1.1 This Highways Technical Note has been prepared in respect of a proposal to construct a new access to serve an existing travellers site on land adjacent to Hawkeridge Road, Heywood, Westbury, BA13 4LE.

1.2 The highway authority has commented as part of a current planning application, noting the following:

Drawing: 2403052-01

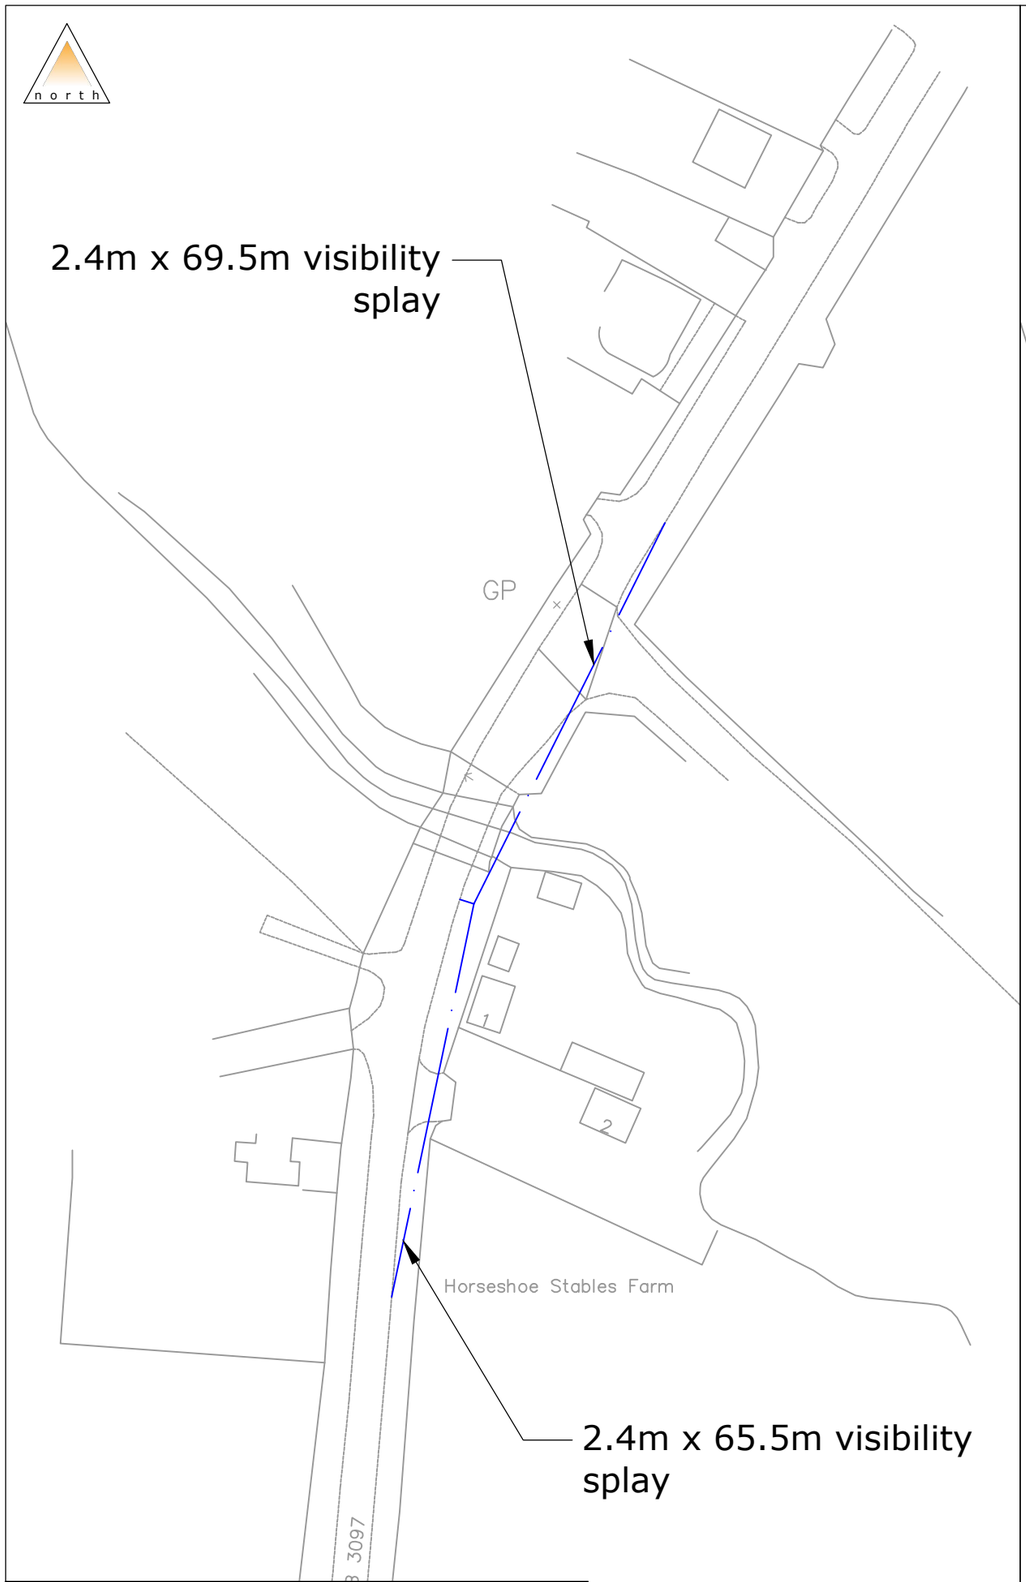
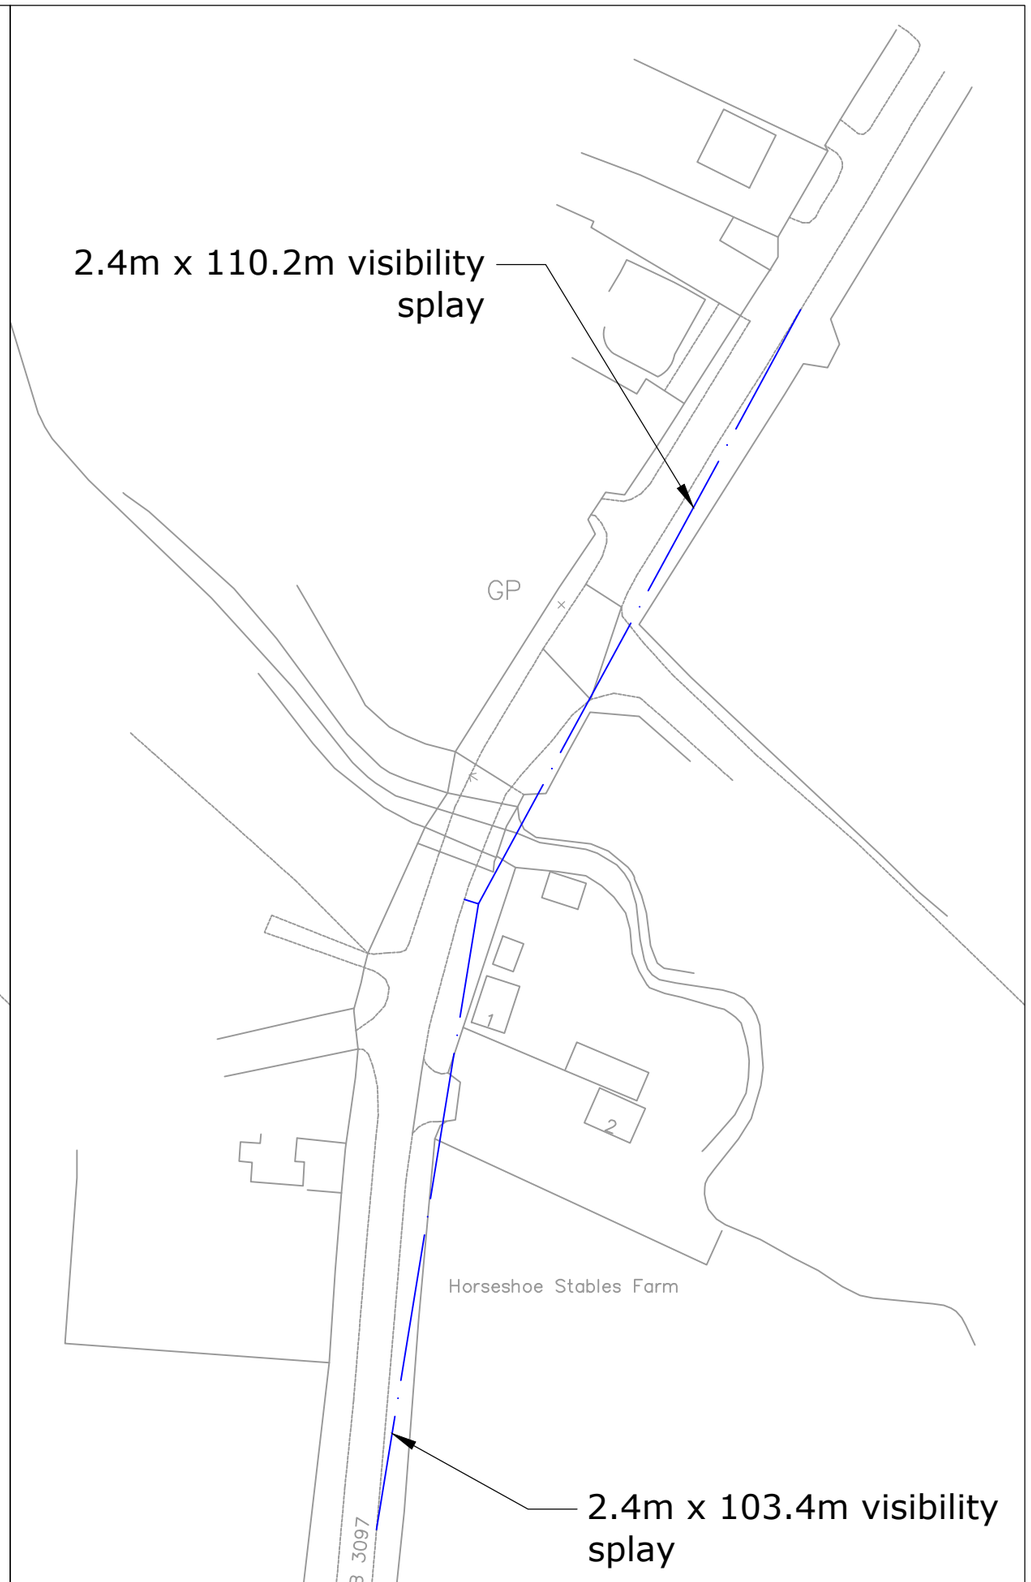
*"I refer to the above planning application for a new access and relocation and extension of permitted dayroom (as its been built in a different location to that previously approved). I have no objection to the extension and relocation of the dayroom. The highway authority have consistently objected to new accesses for this site in the past due to the visibility to the North which falls considerably short of that required in the Design Manual for Roads and Bridges of 160 metres for a 50mph speed limit. Together with this the access is close to the end of the bridge parapet making it susceptible to damage. Furthermore the vertical infill of the parapet will obscure the view [looking north] when leaving the property. I therefore recommend that this application be refused on highway grounds for the following reason: The site has insufficient frontage to the NORTH to enable an access to be satisfactorily laid out incorporating the necessary visibility splays which are essential in the interests of highway safety."*

1.8 Based on MfS guidance the required visibility splays would be 2.4m x 69.5 metres to the north of the site.

1.10 Based on DMRB parameters, the required visibility splays would be 2.4m x 110.2 metres to the north of the site. This splay can be achieved, as illustrated in the access arrangement drawing attached at **Appendix B**. It is likely that some vegetation clearance will be required, although this can be achieved within the extent of highway land. Whilst it is also acknowledged that there is a vehicle restraint barrier to the north of the access, this does not fully obstruct visibility. Vehicles will be visible beyond the barrier, with the barrier only temporarily obstructing visibility. Alternatively the highway authority could require the application to fund the installation of an alternative restraint barrier that reduces an obstruction to visibility, which could be secured via a legal agreement.

1.11 Ultimately it is considered that suitable visibility can be achieved based on recorded vehicle speeds, suggesting a revised access would not be inherently unsafe.
